**RESOLUTION NO. 2022-18**  
(Duly Adopted: September 26, 2022)

A RESOLUTION OF THE BOARD OF SUPERVISORS OF NEW BRITAIN TOWNSHIP GRANTING PRELIMINARY/FINAL LAND DEVELOPMENT APPROVAL TO 84 SCHOOLHOUSE, L.P. OF THE SUBDIVISION AND LAND DEVELOPMENT PLANS FOR 84 SCHOOLHOUSE, L.P., PREPARED BY HOLMES CUNNINGHAM, LLC, DATED MAY 24, 2022, CONSISTING OF 17 SHEETS, WHICH PROPOSE TO CREATE FIVE BUILDING LOTS TO BE IMPROVED WITH ONE SINGLE-FAMILY DWELLING ON EACH LOT.

Reference: 84 Schoolhouse Road, Preliminary Land Development Plan Review 1  
TMP# 26-005-003

**TYPICAL ROADWAY WIDENING SECTION DETAIL FOR  
RESIDENTIAL AND LOCAL ROADS**

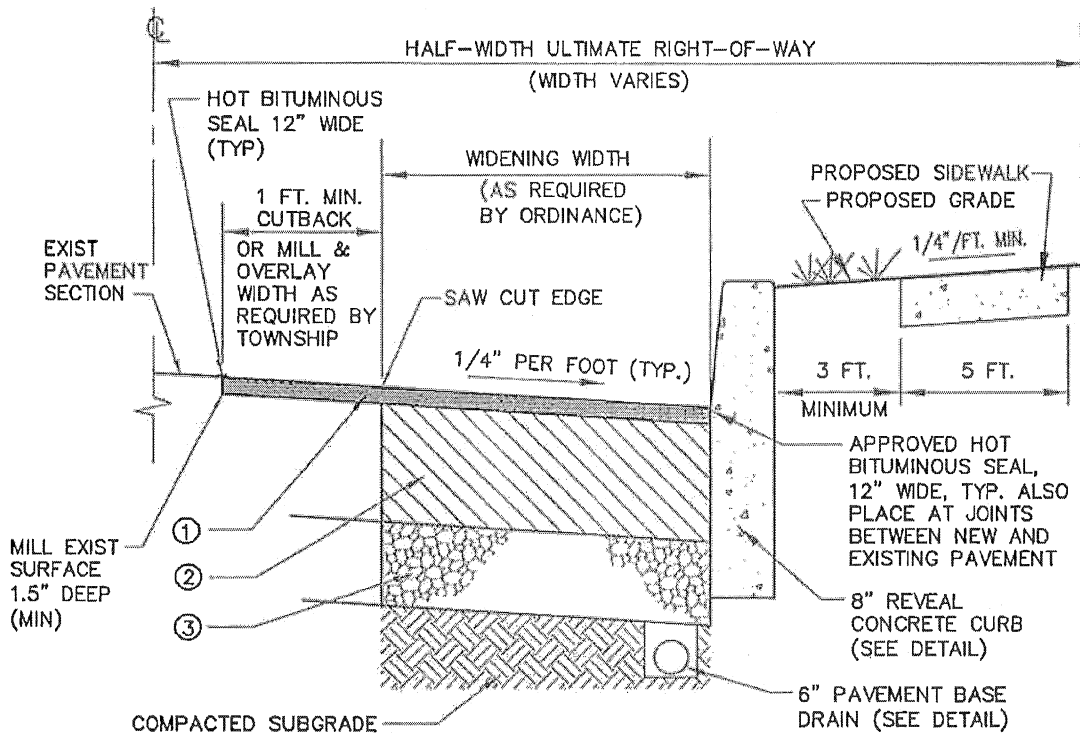
- e. Details shall be provided for the level spreader cleanouts.
  - f. Clarify the private street specification. See attached local street specification.

### PIPE BEDDING DETAIL

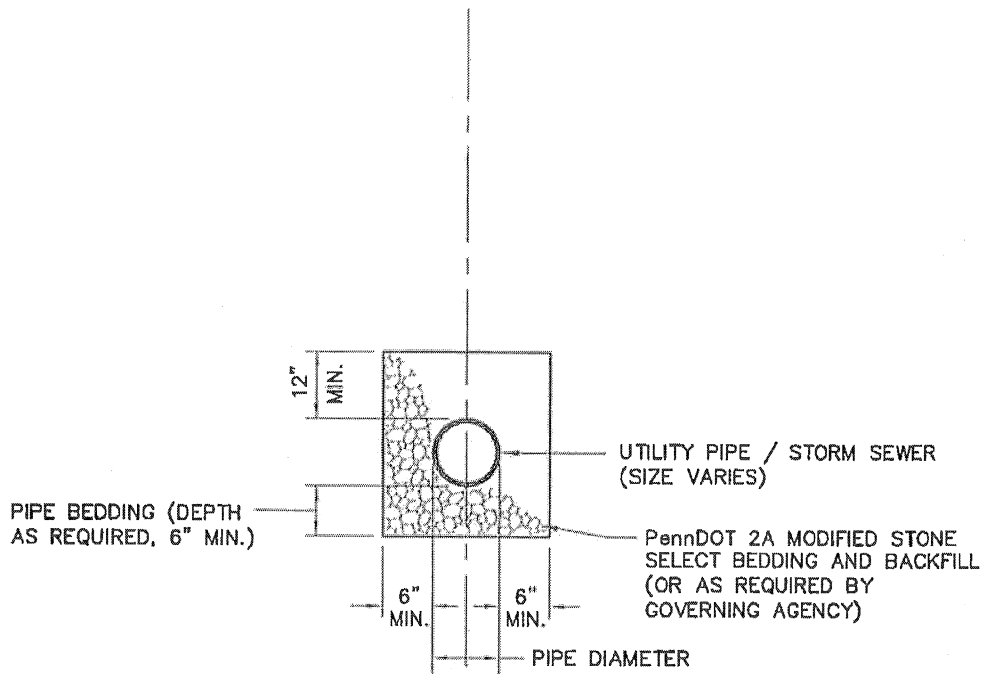
5. 22-502.1.J – The following comments related to construction details shall be addressed:
  - a. The HDPE Pipe Detail shall be replaced with the Township Pipe Bedding Detail.

**STORM SEWER & UTILITY TRENCH RESTORATION WITHIN PAVED AREAS DETAIL**

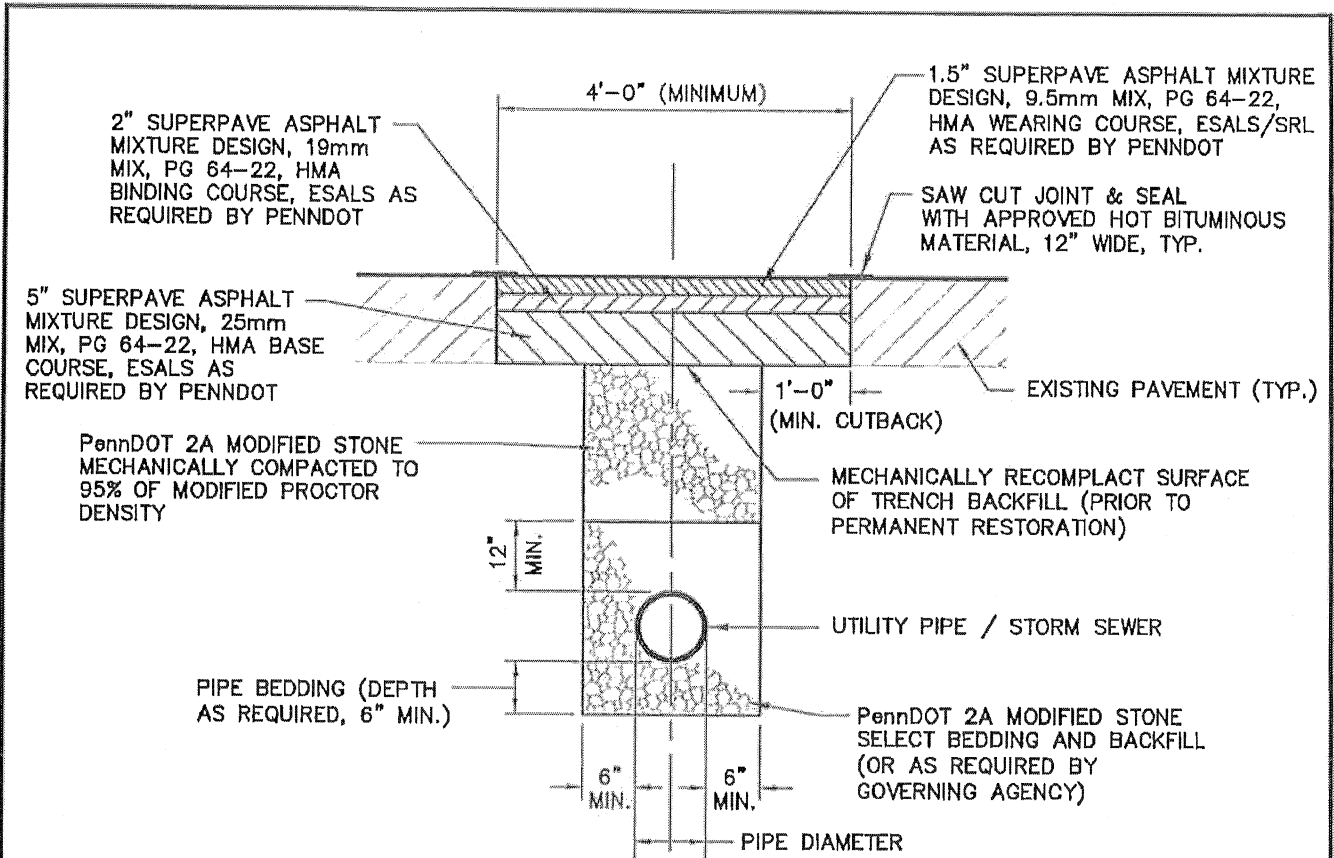
- b. The Township Storm Sewer & Utility Trench Restoration within Paved Areas Detail shall be added to the plans for the restoration of Schoolhouse Road.

**RESIDENTIAL DRIVEWAY  
PAVING SECTION DETAIL**

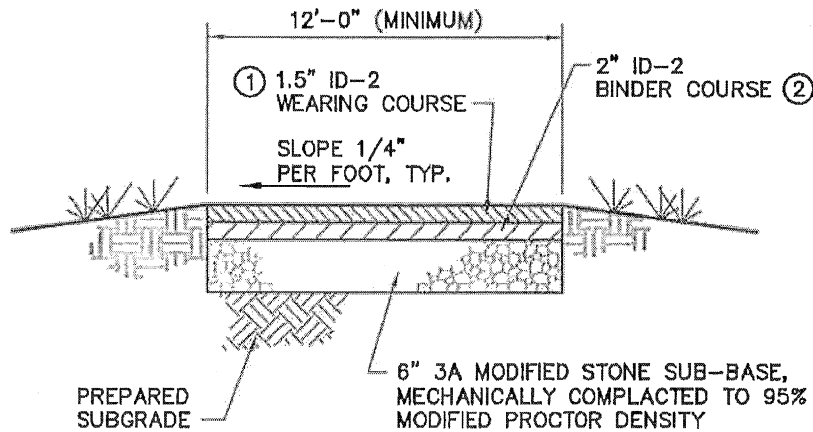
- c. The Township Residential Driveway Paving Section Detail shall be added to the plan for the individual driveways.
  - d. Details for concrete and HDPE flared end sections shall be added to the plans.
